MONTGOMERY COUNTY HISTORIC PRESERVATION COMMISSION
STAFF REPORT

Address:	7315 Brookville Rd., Chevy Chase	Meeting Date:	4/8/2026
Resource:	Individually Listed Master Plan Site Simpson Family House (35/72)	Report Date:	4/1/2026
Applicant:	Paul and Brandy Carlson Great American Landscapes, Agent	Public Notice:	3/25/20206
Review:	HAWP	Staff:	Dan Bruechert
Permit Number:	1151968	Tax Credit:	n/a
Proposal:	Hardscape alterations, grading, pergola and outdoor kitchen construction, retaining wall installation, <u>and tree removal.</u>

THE CARLSON RESIDENCE
 7315 BROOKVILLE RD.
 CHEVY CHASE, M.D. 20815

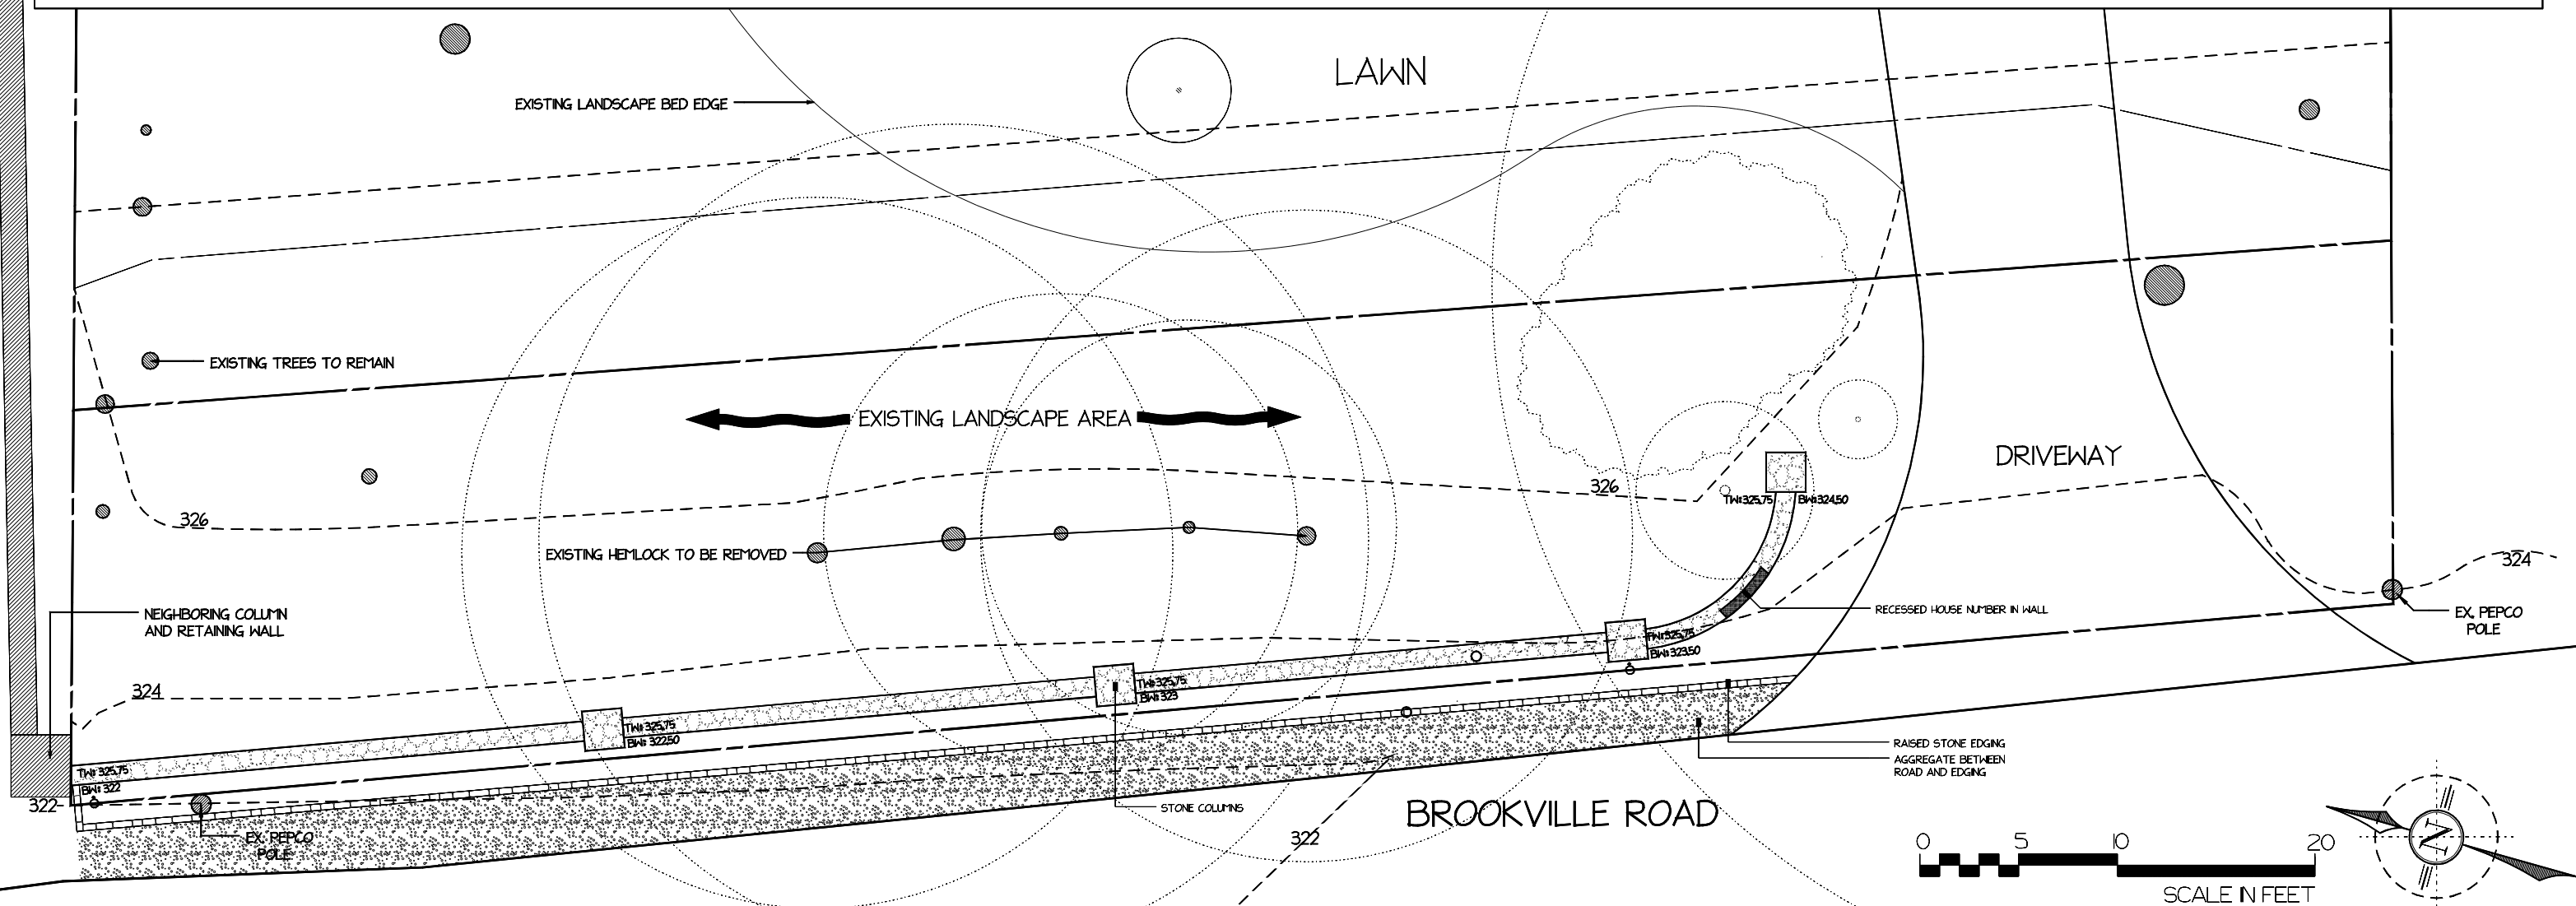
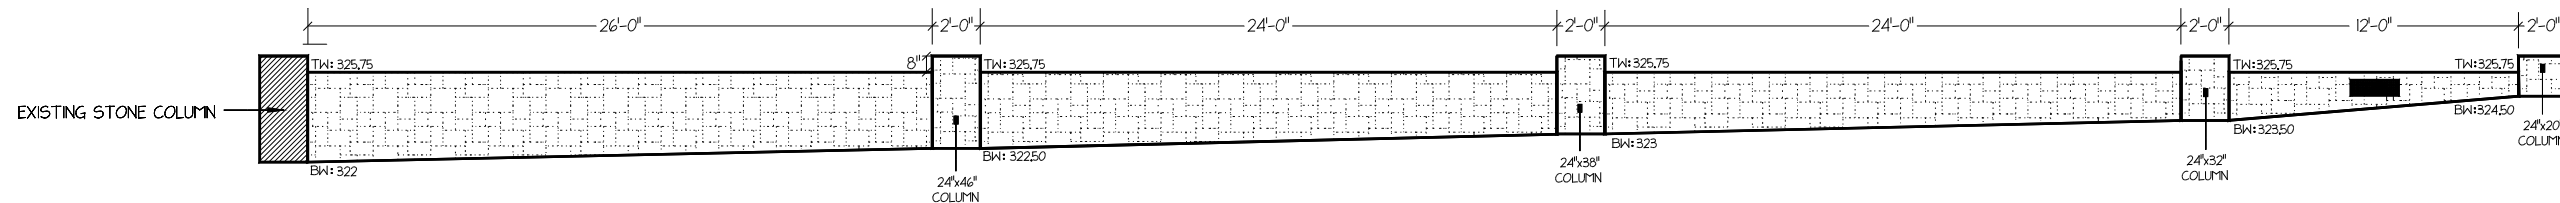
The proposed patio will be constructed out of rectangular flagstones that match the appearance of the driveway/car park paving discussed above. The submitted plans are drawn to scale but do not include notated dimensions of the paving area; however, they appear to be consistent with the existing patio. Staff recommends that the HPC add a condition requiring the final permit drawings include dimensional notations and that these plans must be reviewed and approved before issuing the final HAWP approval documents.

1. A site plan with notated dimensions of the paved areas must be submitted.
2. Scaled elevation drawings and material specifications for the proposed pergola must be submitted.
